Access Compliance Report Public Rights-of-Way (Curb Ramps)

Main Street: N/A Cross Street: HARBOR_BLV Location: SE

ADA ID: RPRK220222170139 Ramp Type: Type 5 - Combination 2 Initial Pass/Fail: Fail Overall Compliance: No Severity Score: 30

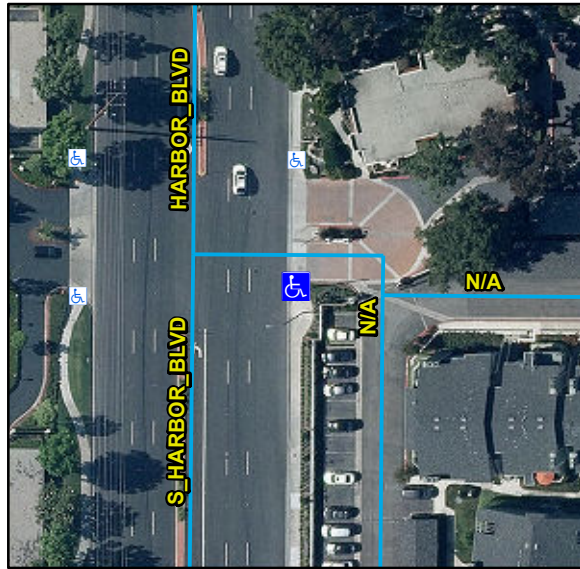
Possible Solutions:

Remove & Replace Entire Ramp.

Compliance	Description	Data	Compliance	Description	Data
N/A	Ramp Length LT (in)	N/A	N/A	Ramp Length RT (in)	132
N/A	Ramp Width LT (in)	N/A	Yes	Ramp Width RT (in)	64
N/A	Ramp Run Slope LT (%)	N/A	No	Ramp Run Slope RT (%)	8.8
N/A	Ramp Cross Slope LT (%)	N/A	No	Ramp Cross Slope RT (%)	6.7
N/A	Ramp Length (in)	68	N/A	Flare Type LT	
Yes	Ramp Width (in)	93			N/A
Yes	Ramp Run Slope (%)	0.6	N/A	Flare Slope LT (%)	N/A
Yes	Ramp Cross Slope (%)	1.3	N/A	Flare Traversable LT	N/A
N/A	Landing Present	N/A	N/A	Flare Type RT	
N/A	Landing Length (in)	N/A			N/A
N/A	Landing Width (in)	N/A	N/A	Flare Slope RT (%)	N/A
N/A	Landing Run Slope (%)	N/A	N/A	Flare Traversable RT	N/A
N/A	Landing Cross Slope (%)	N/A	N/A	DWS Provided	N/A
N/A	Landing Movement Obstructed?	N/A	N/A	DWS Contrast	N/A
	Landing Movement Type	N/A	N/A	DWS Length (in)	N/A
N/A	Landing Shared	N/A	N/A	DWS Full Width	N/A
N/A	Clear Space	N/A		DWS Offset Type	N/A
N/A	Clear Space To Crosswalk (in)	N/A	N/A	DWS Offset Left (in)	N/A
